# UNITED STATES PATENT AND TRADEMARK OFFICE

APPLICATION NO.	FILING DATE	FIRST NAMED INVENTOR	ATTORNEY DOCKET NO.	CONFIRMATION NO.
10/787,429	02/26/2004	Joseph D. Rippolone	67067-012	4762
26096 7590 06/04/2007 CARLSON, GASKEY & OLDS, P.C. 400 WEST MAPLE ROAD SUITE 350 BIRMINGHAM, MI 48009			EXAMINER HORTON, YVONNE MICHELE	
			ART UNIT 3635	PAPER NUMBER
			MAIL DATE 06/04/2007	DELIVERY MODE PAPER

## Office Action Summary

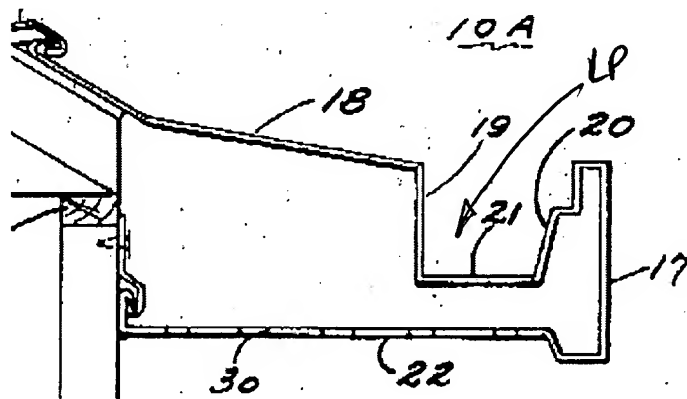
Claims 2,3,6 and 12 are rejected under 35 U.S.C. 102(b) as being anticipated by US Patent #3,824,749 to SCHERF. In reference to claim 12, SCHERF discloses a molded gutter section (10A) including a liquid passage (LP), an air flow passage (29 or 30) adjacent thereto,

and a gutter wall (21) separating the liquid and air (29 or 30) passages; wherein the gutter (10A) includes two spaced apart walls (19,20) and a bottom wall (22) such that

the air passage extends through the bottom wall (22). Regarding claim 2, the air flow passage (29 or 30) is located within the bottom wall (22). In reference to claims 3 and 6, the air flow passages (29 or 30) comprises multiple linear air flow passages.
